LR-N03-0136

**RESPONSE TO REQUEST FOR ADDITIONAL INFORMATION REGARDING
CHANGE TO TECHNICAL SPECIFICATION RELATING TO CONTAINMENT
CLOSURE AND FUEL HANDLING VENTILATION
SALEM GENERATING STATION UNIT NOS. 1 AND 2
FACILITY OPERATING LICENSE NOS. DPR-70 AND DPR-75
DOCKET NOS. 50-272 AND 50-311**

**SALEM GENERATING STATION
UNIT NOS. 1 AND 2
FACILITY OPERATING LICENSE DPR-70 AND DPR-75
DOCKET NOS. 50-272 AND 50-311
RESPONSE TO REQUEST FOR ADDITIONAL INFORMATION
CONTAINMENT CLOSURE AND FUEL HANDLING AREA VENTILATION**

Figure 1

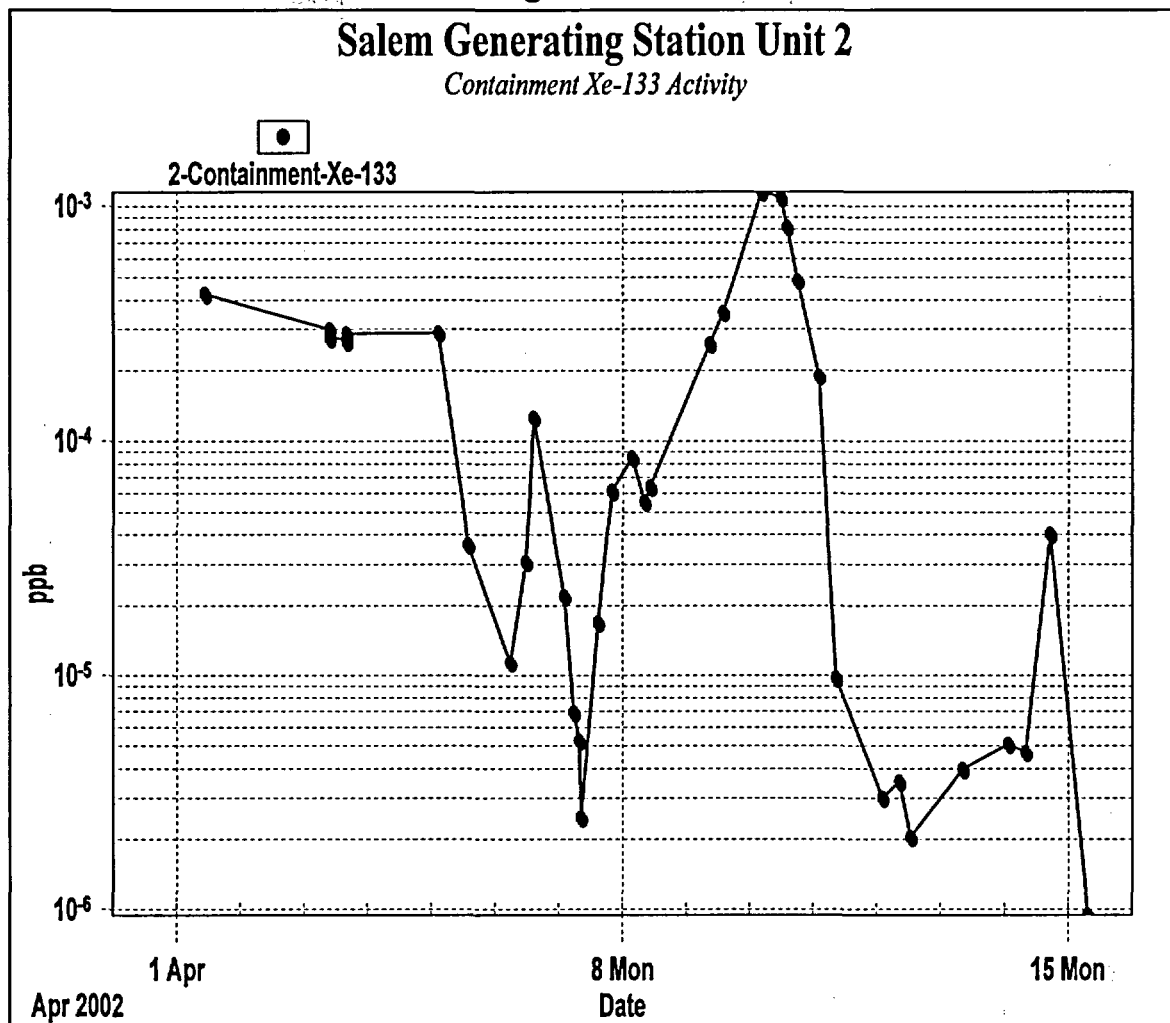
According to the submittal, the containment purge system and the auxiliary building ventilation systems can draw a negative pressure on the containment with the equipment hatch open. Describe the analyses that were performed to verify that these systems can draw down the containment with the equipment hatch open.

The ability to draw a negative pressure on the containment was based on past operating experience. As an example, during the Unit 2 12th refueling outage high airborne activity in the containment caused an automatic isolation of the containment purge system, which isolated the ventilation flowpath in and out of containment. To reduce the airborne activity in containment, the personnel airlocks and the refueling outage equipment door were opened with the Auxiliary Building Ventilation System (ABVS) in service to allow the ABVS to draw the air out of containment and reduce the containment airborne activity. As shown in Figure 1 and Table 3, the containment airborne activity level decreased which demonstrated the ability of the ABVS to draw the air from the containment with the personnel airlocks open. The exhaust from the ABVS is monitored by the plant vent radiation monitors.

The data provided in Figure 1 and corresponding Table 3 supports the justification for the statements made in the PSEG submittal.
